Addenda No. 6

SUBJECT: I-84: Multnomah Falls - Cascade Locks Section
Columbia River Highway
Multnomah & Hood River Counties
Grading, Structures, Paving, Guardrail, Pavement Markings, Signing &
Automatic Traffic Recorder Project

The following changes are made to the Project Bid Booklet:

SHEET NO. 3

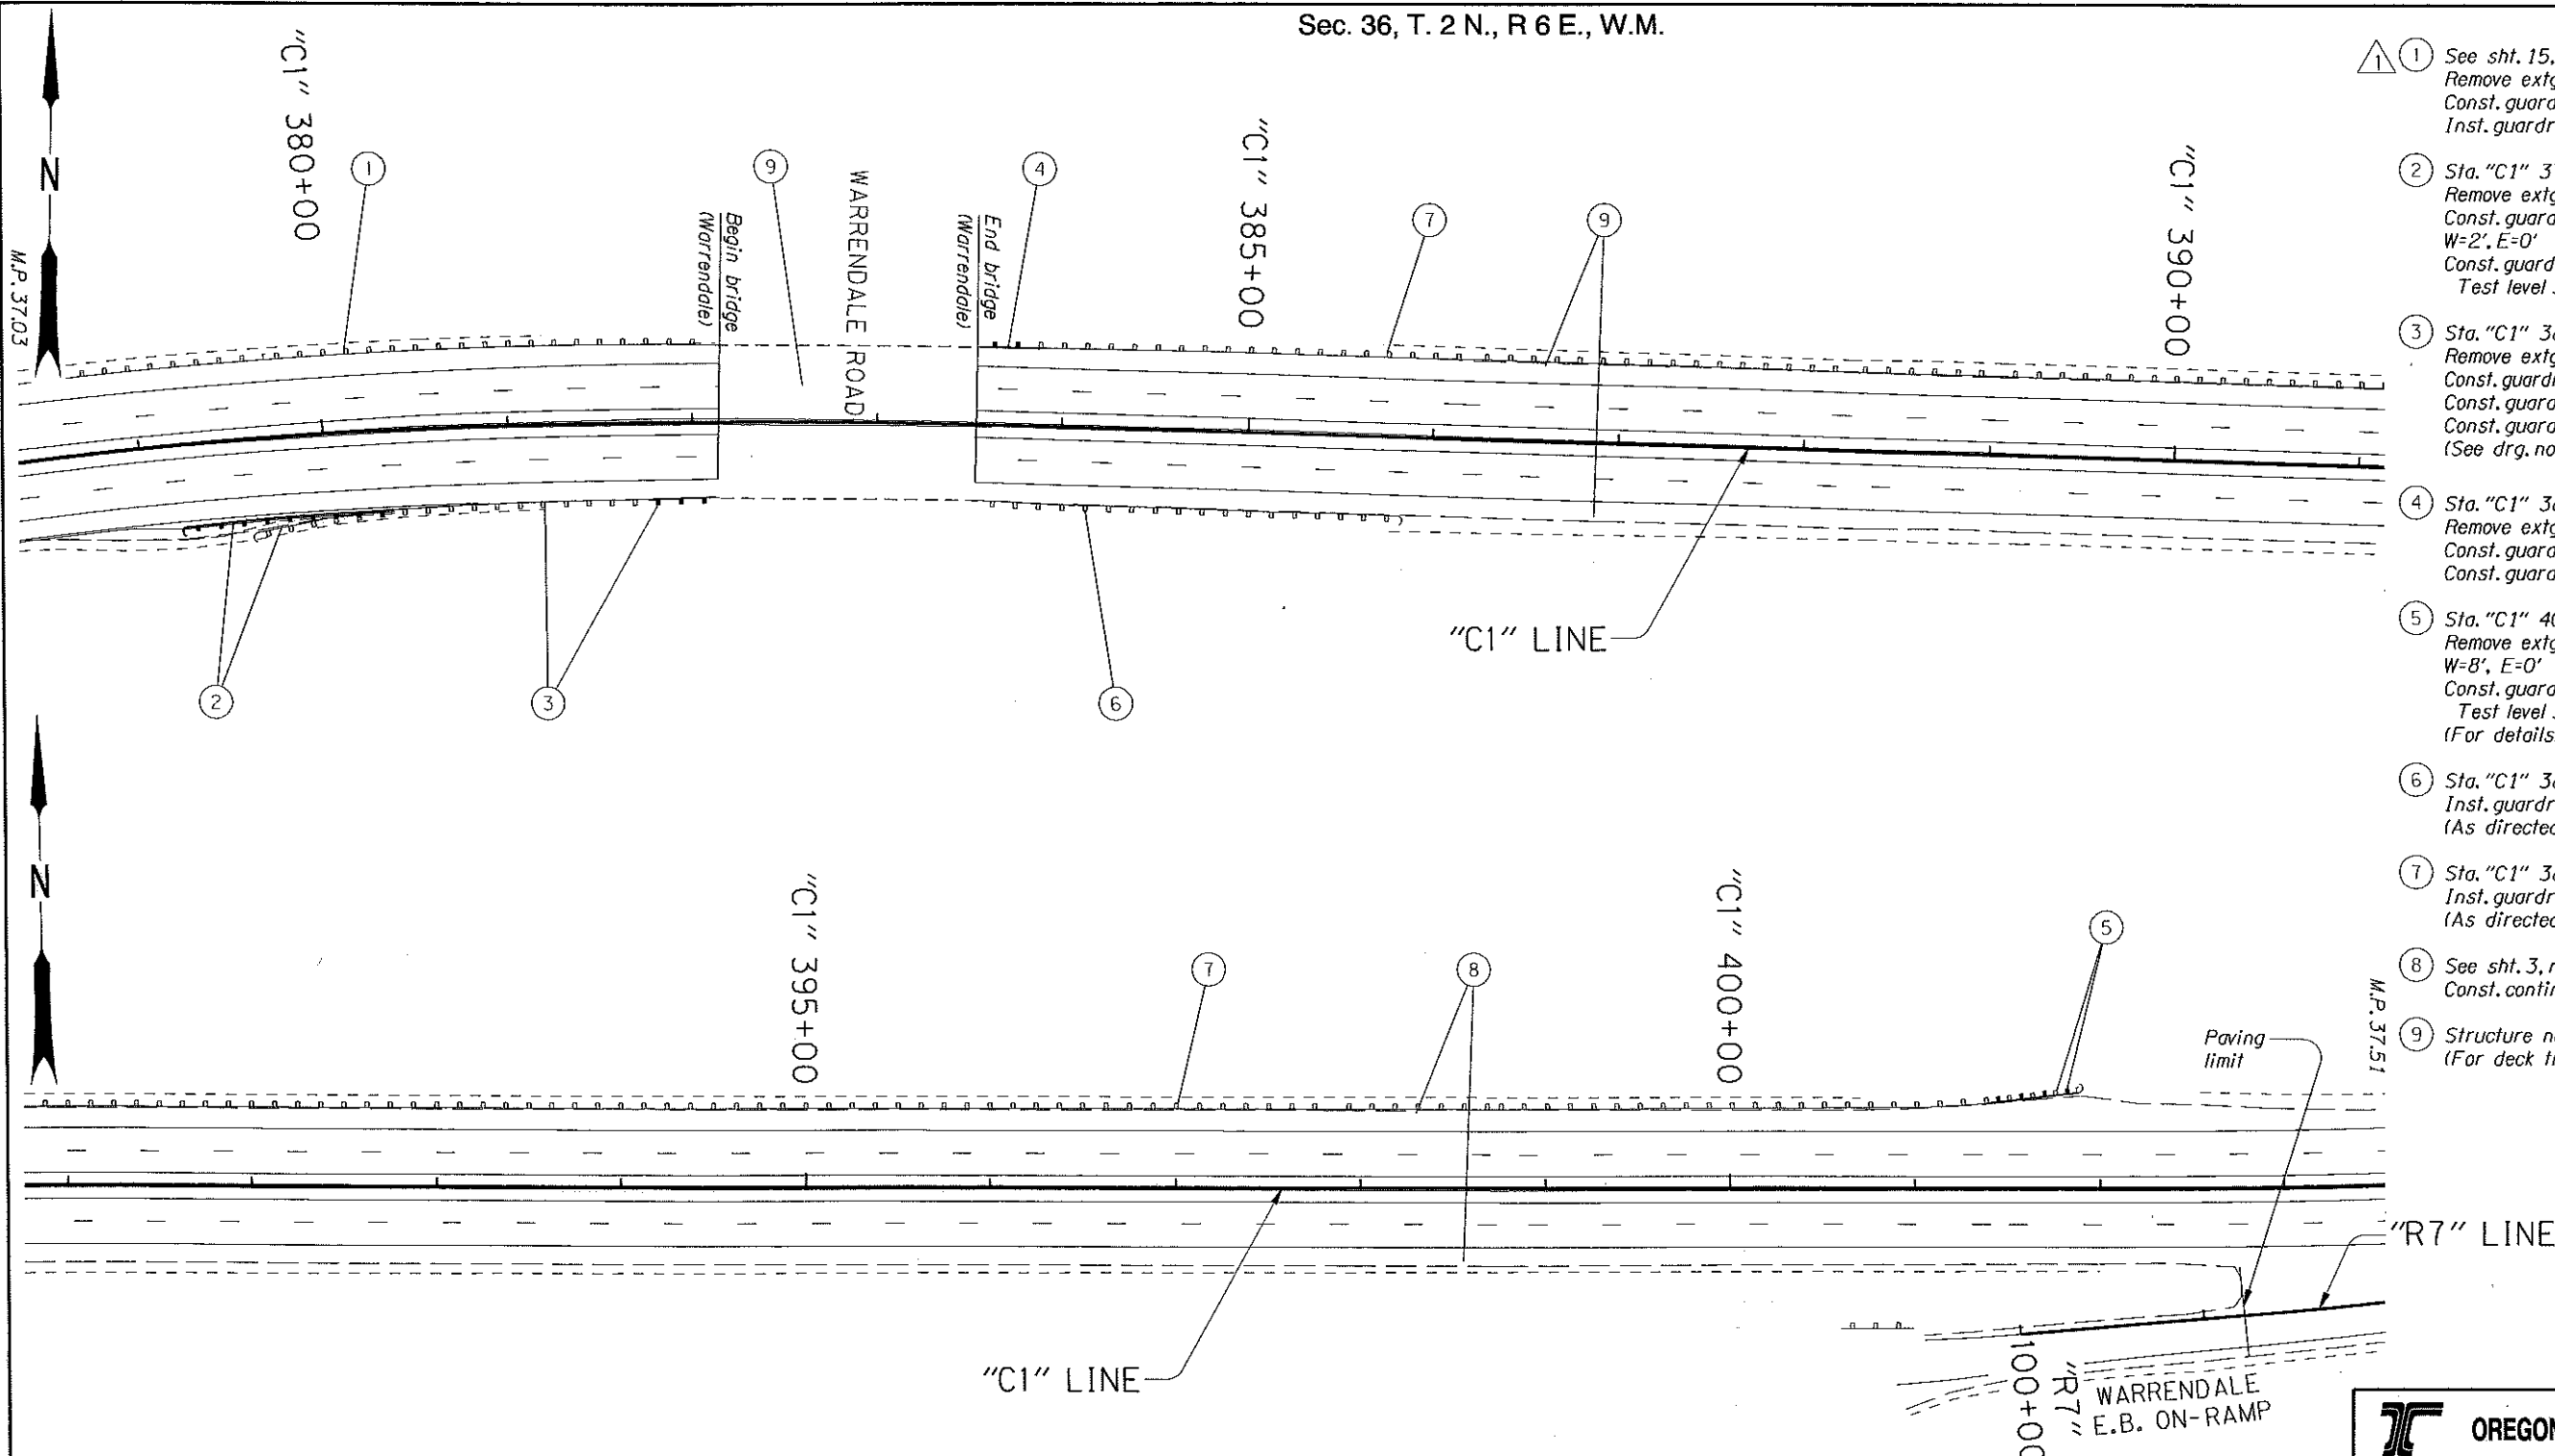
REVISIONS	
①	Revised 7-8-2009
	Revised Note

- ① See sht. 15, note 4
Remove extg. guardrail (Rail only)
Const. guardrail (Rail only) (Type 2A, weatherized)
Inst. guardrail posts
- ② Sta. "C1" 379+21.7 to Sta. "C1" 380+81.9, Rt.
Remove extg. guardrail - 112.5'
Const. guardrail - 275' (Type 2A, weatherized)
W=2', E=0'
Const. guardrail terminal, non-flared, weatherized - 50'
Test level 3

SHEET NO. 16

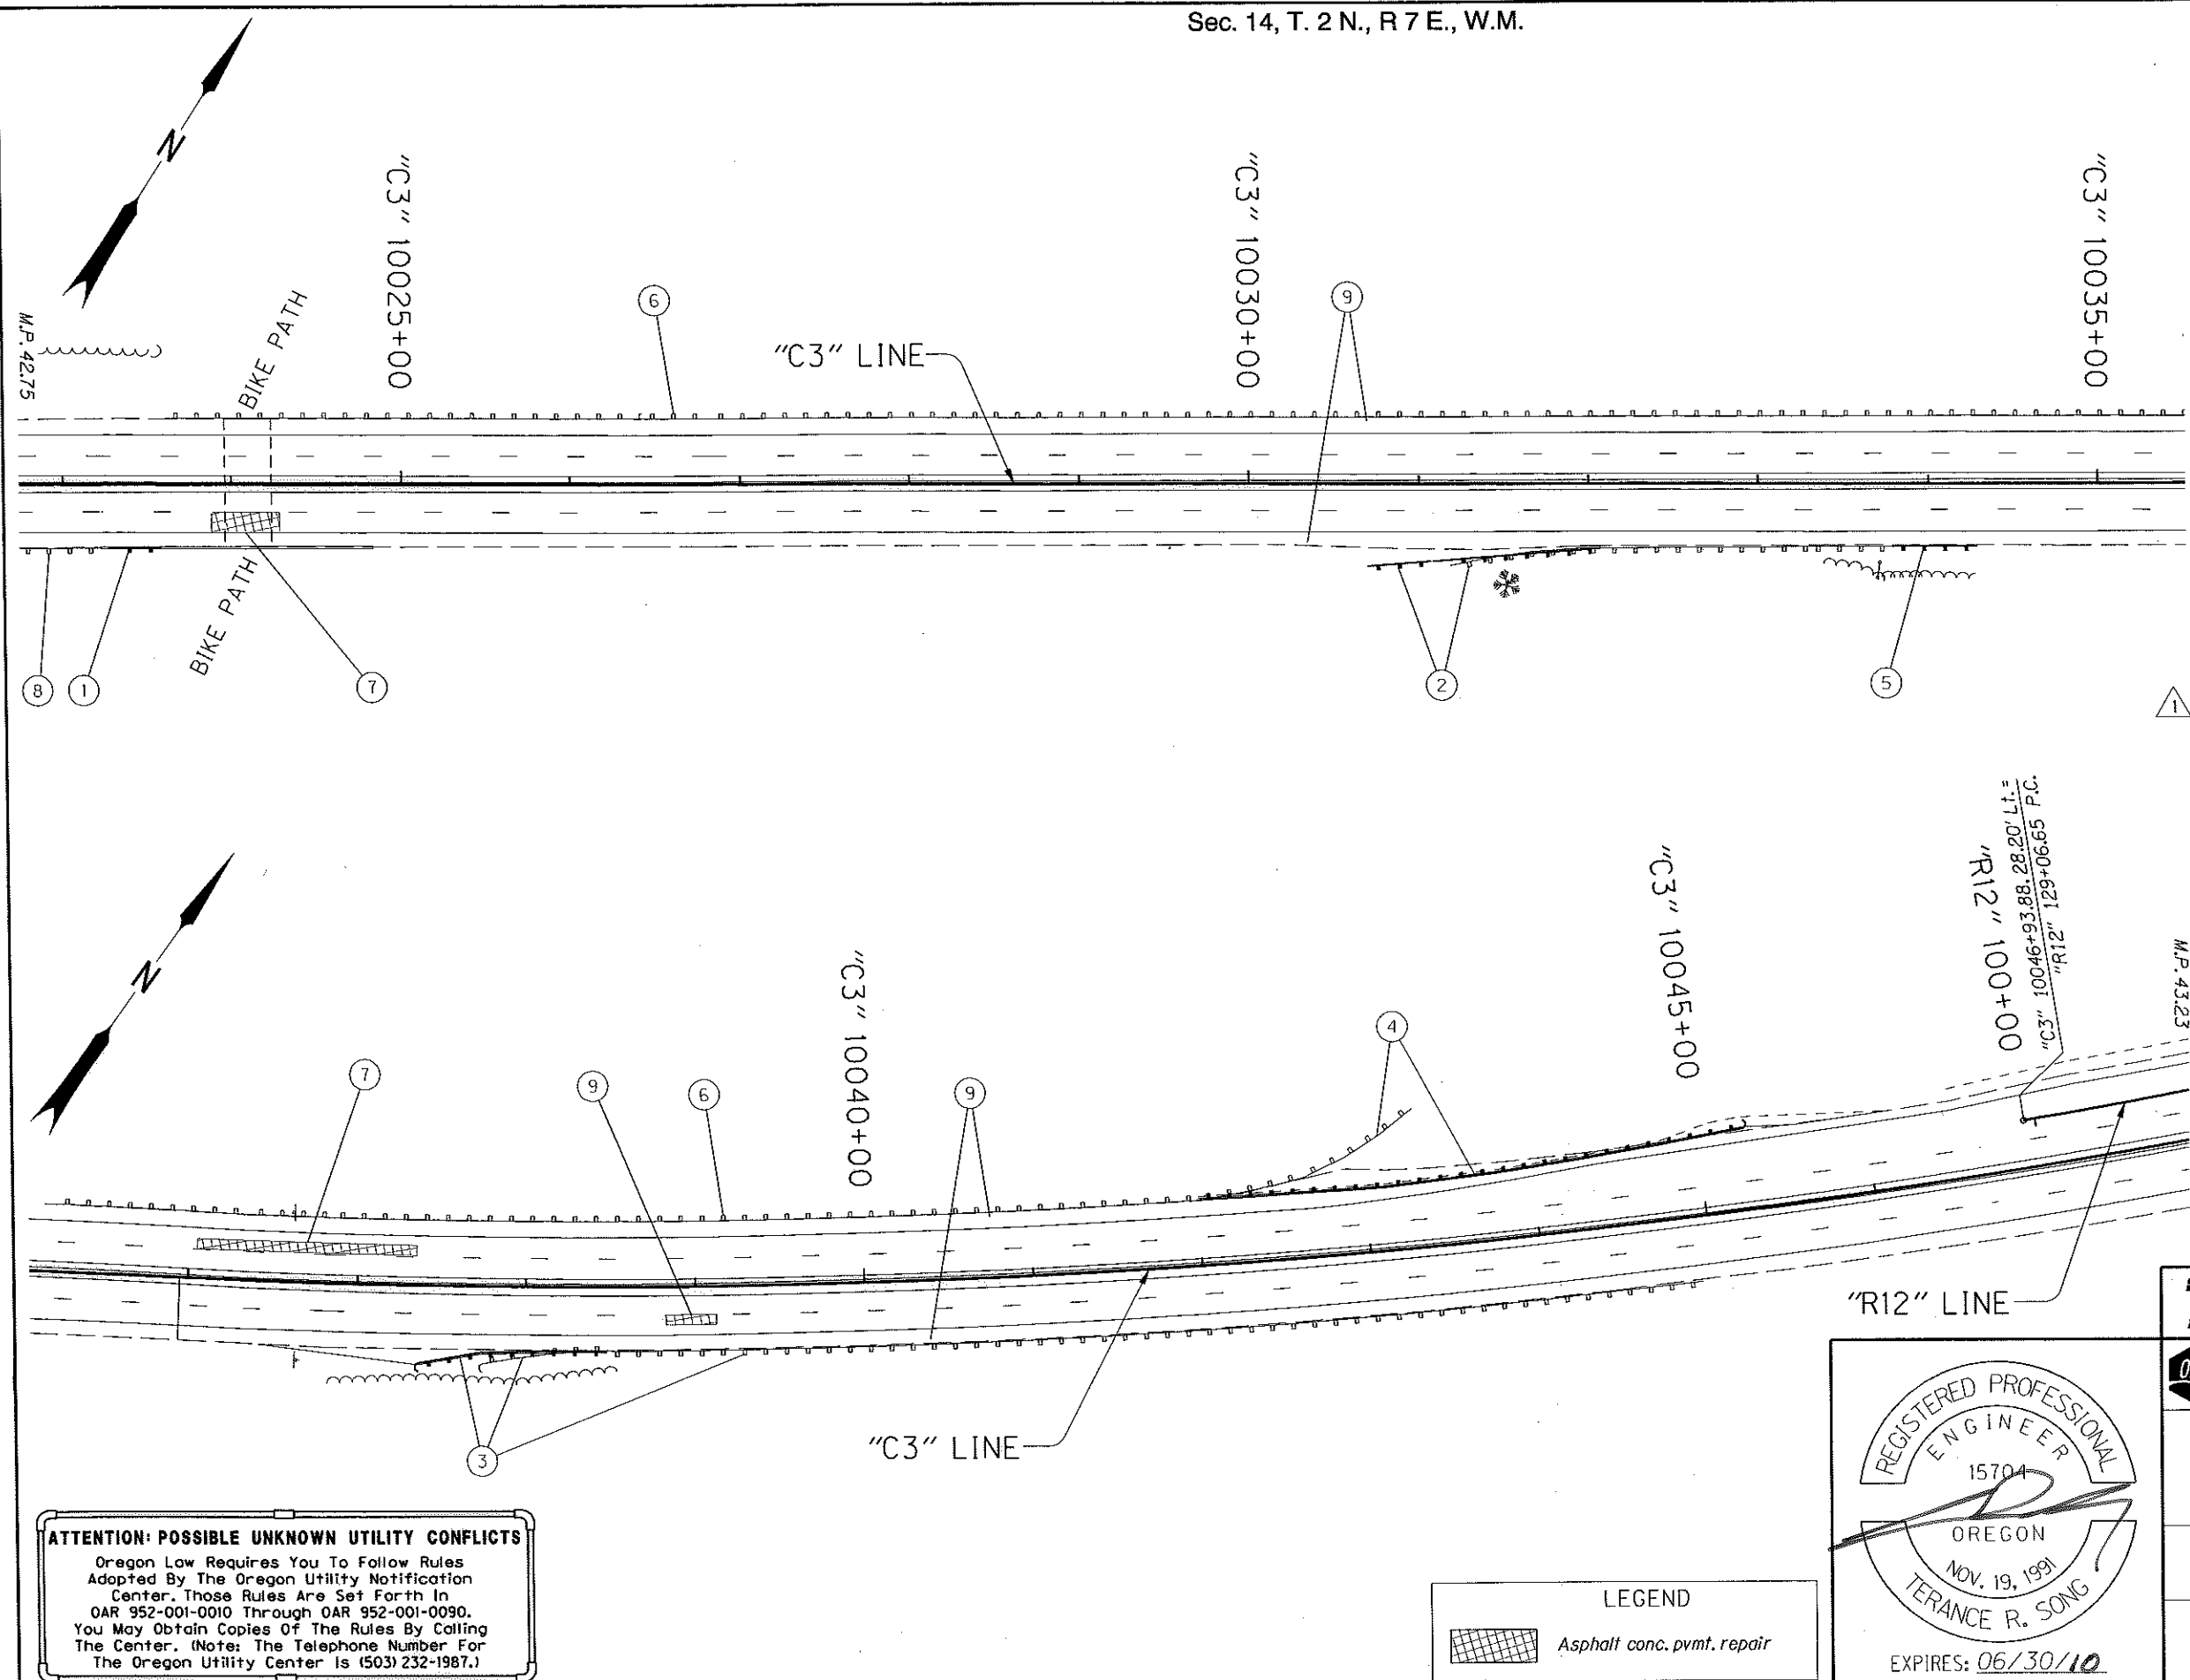
REVISIONS	
⚠️	Revised 7-8-2009 Revised Note

- ⚠️ ⑤ Sta. "C3" 10031+23.1 to Sta. "C3" 10034+28.9, Rt.
Const. guardrail - 50' (Type 2A, weatherized)
Const. anchor (Type 1 modified, weatherized)
Inst. end piece (Type B, weatherized)
E=0'
Inst. guardrail posts - 5
(As directed by Engineer)

SHEET NO. **30**

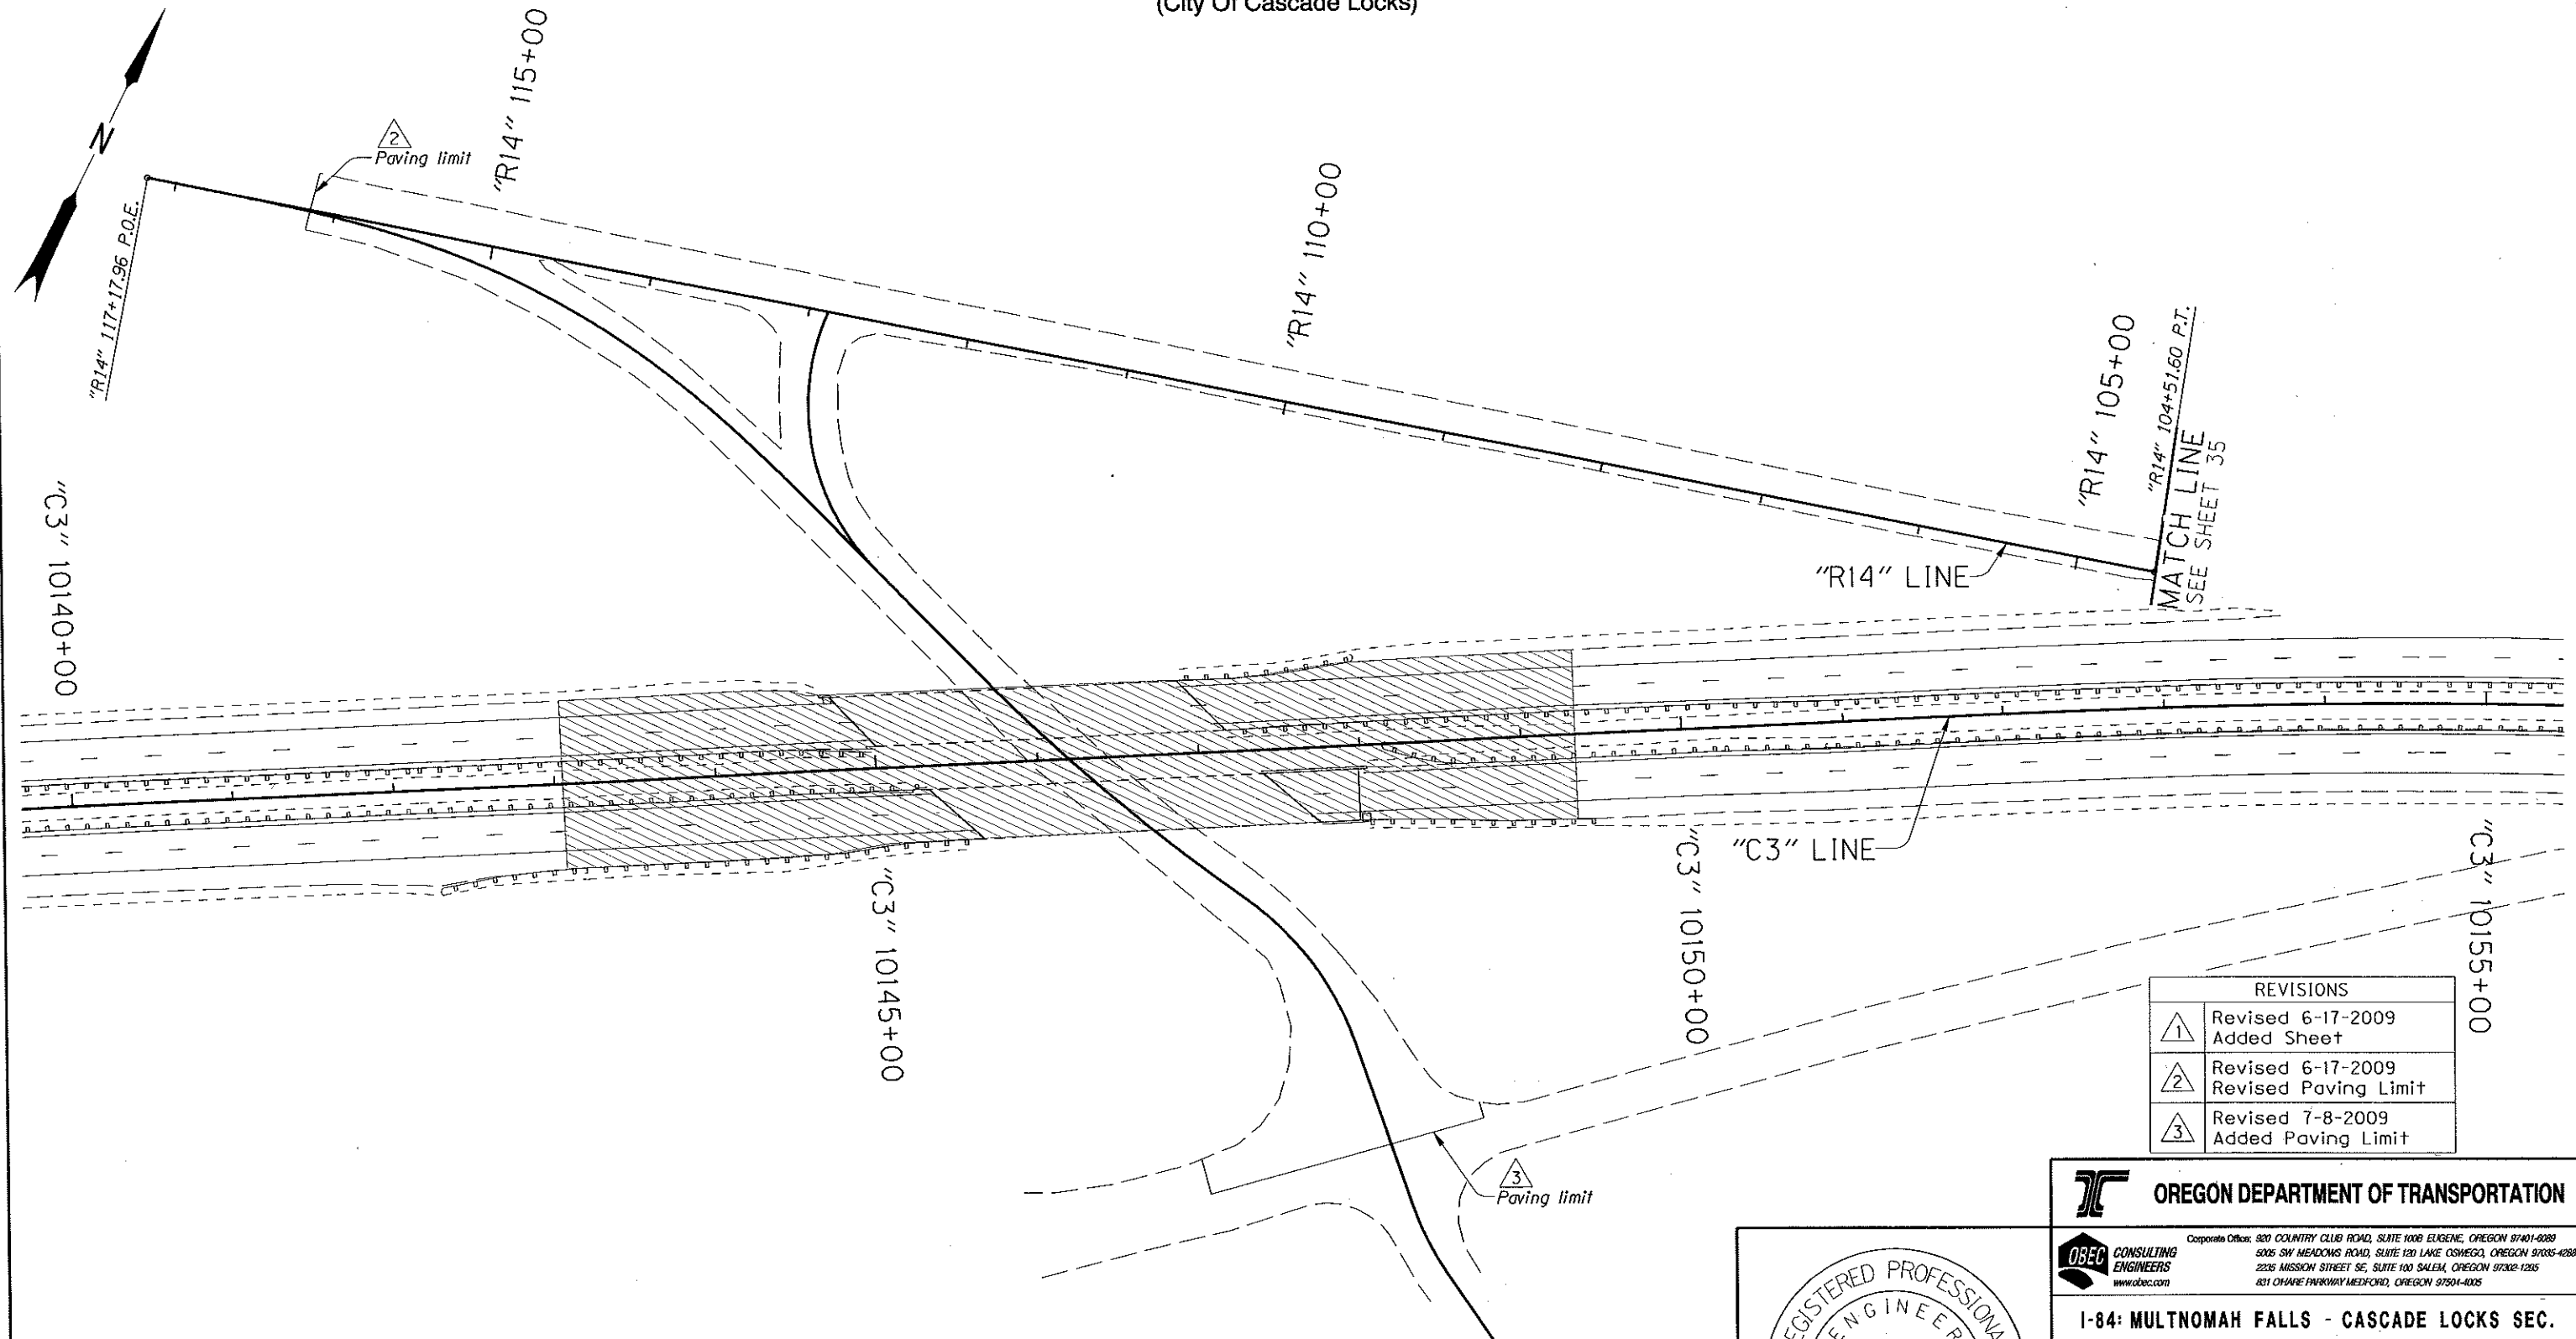
REVISIONS	
①	Revised 6-17-2009 Added Sheet
②	Revised 6-17-2009 Revised Paving Limit
③	Revised 7-8-2009 Added Paving Limit
